Bradwell Power Station

Response to Environment Agency questions

DEM7610-RT001-R02-00

Figure 2.1: Predicted FED dilution 100 m from outfall

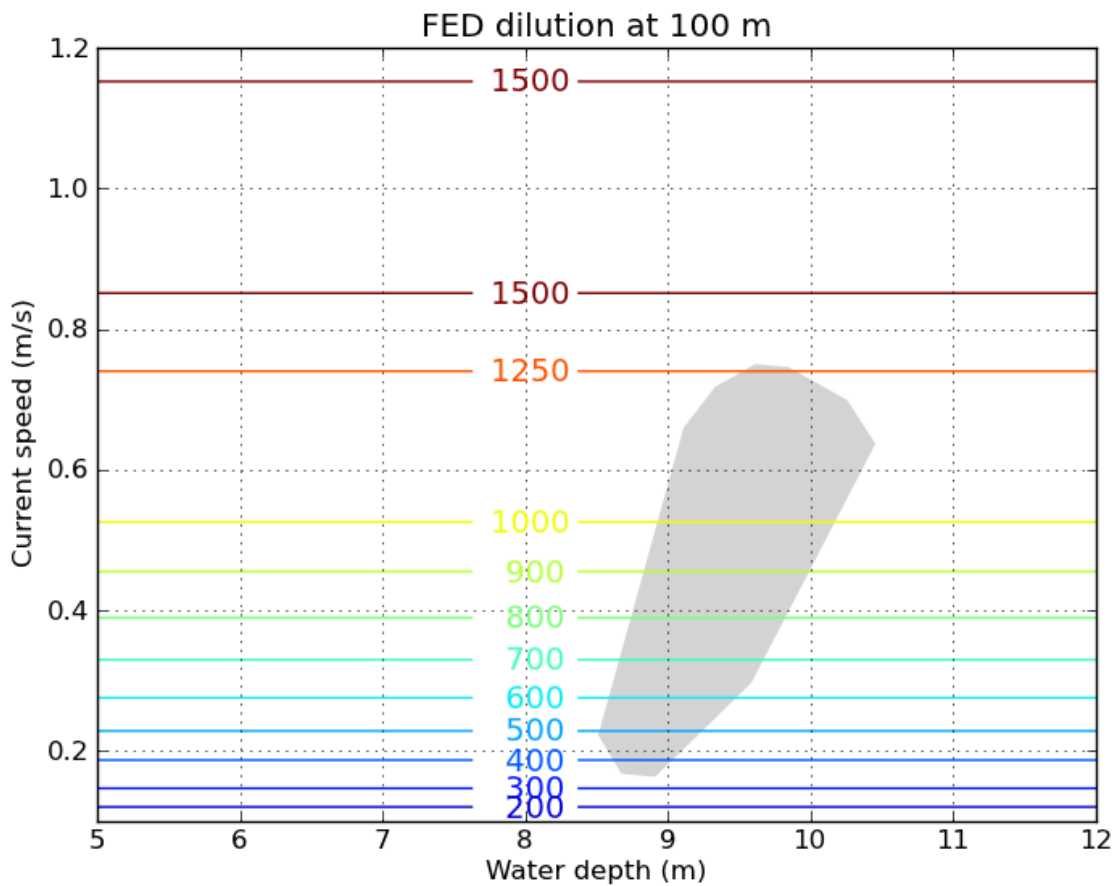
2.2. A Figure similar to Figure 5.6 for the FED discharge

Figure 2.1 shows the predicted FED dilution 100 m from the outfall. The contours of dilution are straight lines because the dilution does not depend on the water depth. The area shaded grey marks the combinations of water depth and current speed that are expected to occur during the discharge window.

Figure 2.2: Predicted distance to bed impact

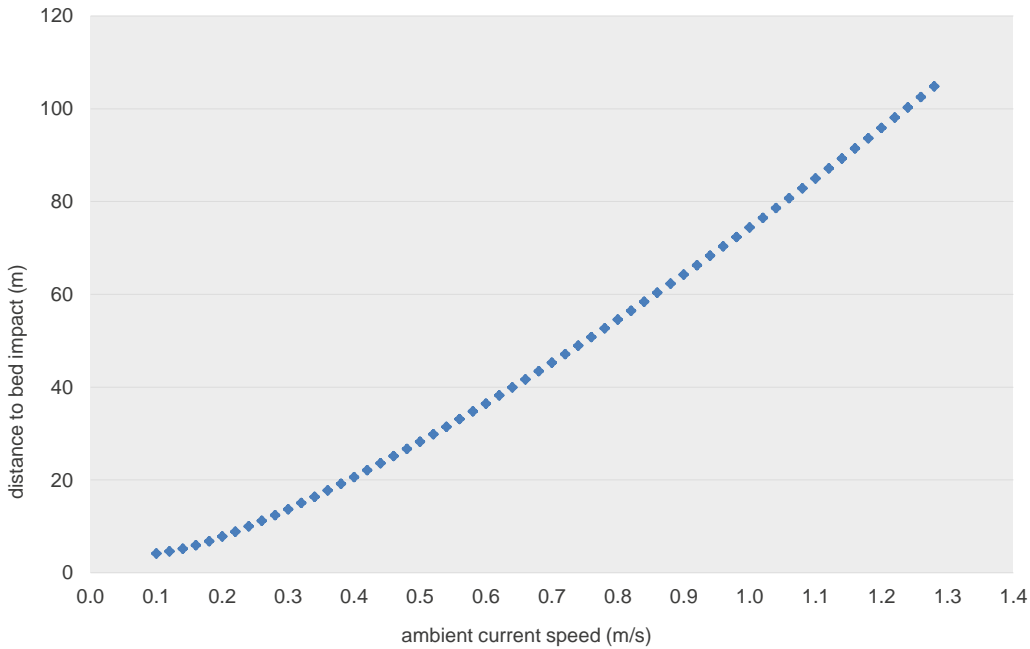
2.3. Position and concentration of FED plume at bed impact

Figure 2.2 shows the distance to the point where the FED plume reaches the bed, as a function of current speed. Figure 5.2 in Reference 1 showed the dilution at this point – reproduced here as Figure 2.3 for convenience.

Figure 2.4: Predicted nitrate concentrations, averaged over one day, spring tide (left) and neap tide (right)
Source: Based on Reference 2, Figures 4.3 and 4.4. (Release at HW+1)

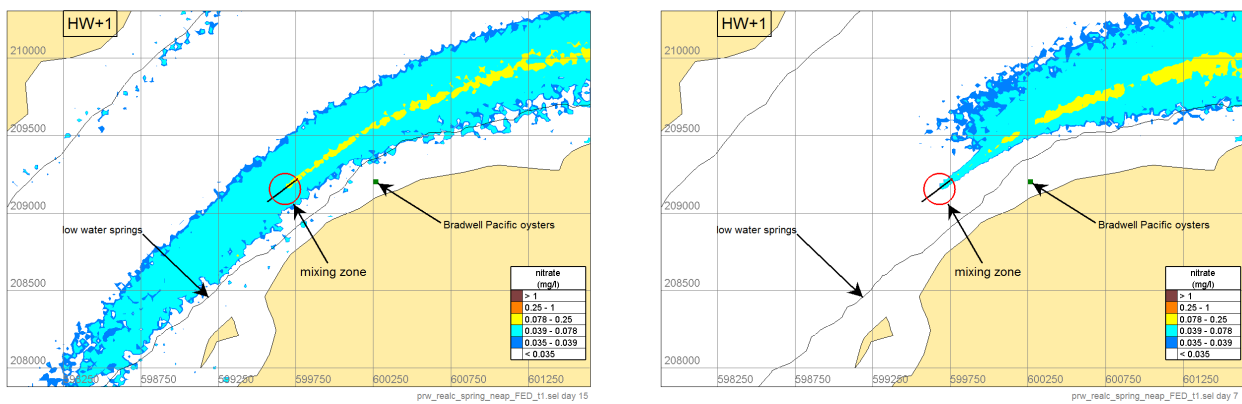
Impacts at the oyster beds were considered in Reference 2. The Agency has asked for further details. Figure 2.4 shows a zoomed-in picture of the plume footprint on spring tides and neap tides. These images are based directly on the relevant panels of Figures 4.3 and 4.4 in Reference 2, for the discharge window starting at HW+1.

The figure shows the mixing zone (approximated to a circle of radius 100 m around the outfall), the location of Bradwell Pacific Oysters, and the contour of Low Water Springs (LWS). Oysters only grow in intertidal areas, and so the LWS contour is the offshore limit of their viable habitat – areas further from the shore are never uncovered.

The figure shows that the plume footprint is confined largely offshore of LWS, and since the oysters are confined onshore of LWS, there is expected to be negligible overlap of the plume with the oyster beds. Notice also that the separation of the oyster bed location from the edge of the mixing zone is around 500 m (five times the size of the zone radius).

Figure 2.5: Sketch of the FED plume in the zone of influence: plan view looking downwards

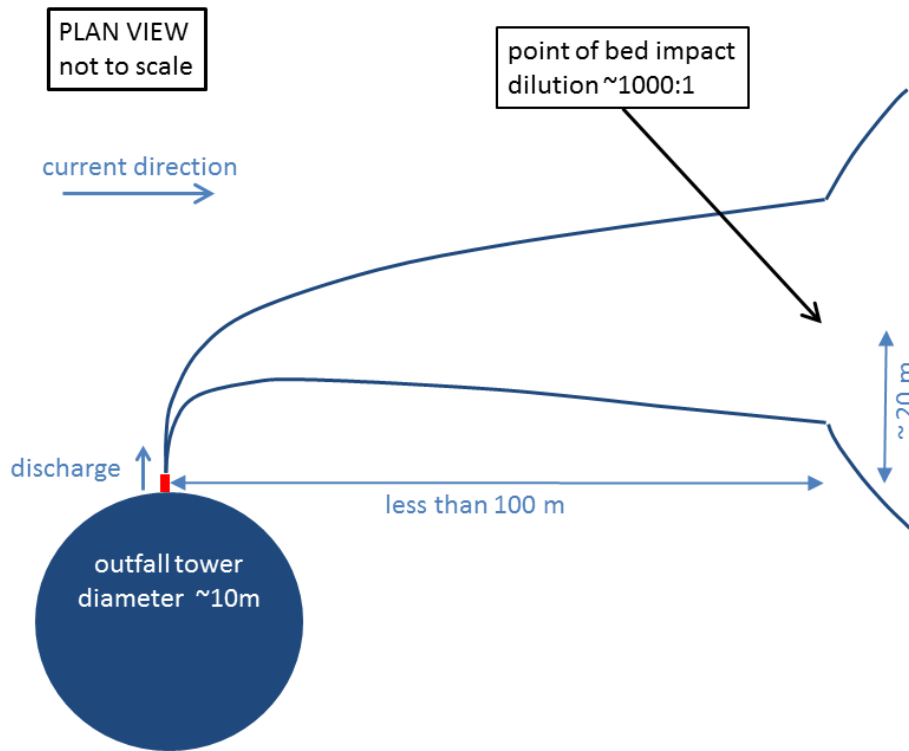
2.9. More detail about the size and shape of the FED discharge's zone of influence

The plume will have a very complex shape, as its motion is affected by its momentum leaving the outfall, the effect of gravity as it falls towards the bed under its higher density, and deflection by the ambient currents. The sketches in Figure 2.5 and Figure 2.6 illustrate the general size and shape of the plume as it leaves the outfall, until it impacts with the bed. As has been noted previously, the dilution at this point is around 1000:1 (averaged over discharge windows) and so the concentrations of all constituents in the FED are very low outside this region – see the tables in Section 2.6. For this reason, it is appropriate to regard this region, extending less than 100 m from the outfall as the “zone of influence” of the discharge.
